# Newmar Corporation Warranty Department

<b>Technical Service Bulletin</b>								
Date Iss	sued	Model Yea	r(s) A	ffected		TSB #		
11/16/2015		2016				434		
Brand								
Bay Star Sport	X	Ventana		Essex				
Bay Star	X	Dutch Star		King Aire				
Canyon Star	X	Mountain Aire		Other				
Ventana LE		London Aire						
Description								
In response to notification from Ford Motor Company, Newmar Corporation has decided that a defect which relates to motor vehicle safety exists in specific motor homes. Newmar Corp has built motorhomes on the affected chassis. Therefore, Newmar has decided certain 2016 motorhomes manufactured on Ford F-53 and F-59 chassis are subject to the Ford Transmission Shift Cable Campaign FSA 15S25. Newmar NHTSA# 15 v 713, TC # 2015-512

## CERTAIN 2016 MODEL YEAR FORD F-53 MOTORHOME AND F-59 STRIPPED CHASSIS VEHICLES — TRANSMISSION SHIFT CABLE BRACKET REPLACEMENT

FIGURE 1

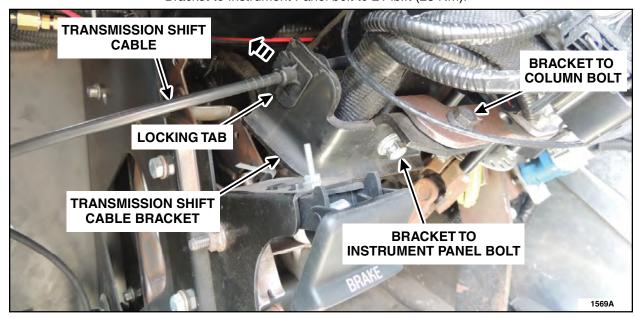
- Remove the lower steering column trim/knee bolster panel as necessary to gain access to the lower steering column area. Refer to the Coach Builders Repair Manual for additional information if necessary.
- 2. Remove the transmission shift cable bracket. See Figure 1.
  - a. Carefully lift the locking tab and disconnect the transmission shift cable from the bracket.
  - b. Remove the two bolts and the transmission shift cable bracket.
    - When installing the bolts, torque to the following specifications:
      - Bracket to Column bolt to 36 lb.ft (48 Nm).
      - Bracket to Instrument Panel bolt to 21 lb.ft (28 Nm).

- 3. To install the *new* transmission shift cable bracket, reverse the removal procedure.
- 4. Perform the Selector Lever Cable Adjustment procedure. Please follow Workshop Manual (WSM) procedures in Section 307-05.
